RE: Additional Information requested

**POTENTIAL FOR INDUCED SEISMICITY RELATED TO THE
NORTHERN CALIFORNIA CO₂ REDUCTION PROJECT PILOT TEST,
SOLANO COUNTY, CALIFORNIA**

Vulnerability Evaluation Framework Review ¹

Non-confidential Draft UIC Comments from C6 Resources LLC

Figure 1: Screen shot of the CGS *2010 Fault Activity Map of California* for the Montezuma Hills area. Yellow dot is the proposed well location.

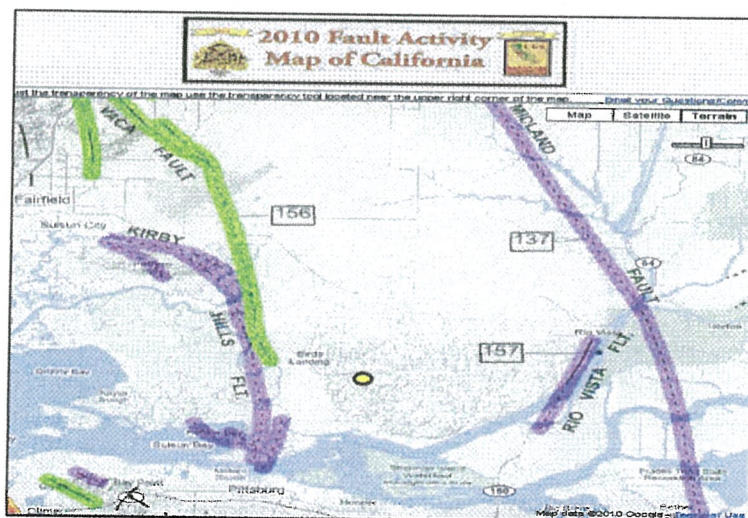
Since completion of the draft, a couple of items that require clarification have come to our attention:

1. Recently, and since the preparation of the draft report, the California Geological Survey (CGS) released a digital map titled, *2010 Fault Activity Map of California*, which shows the locations of known faults and age ranges of surface rupture or displacement. A screen shot of this map zoomed in to the Montezuma Hills area is shown in the figure below.
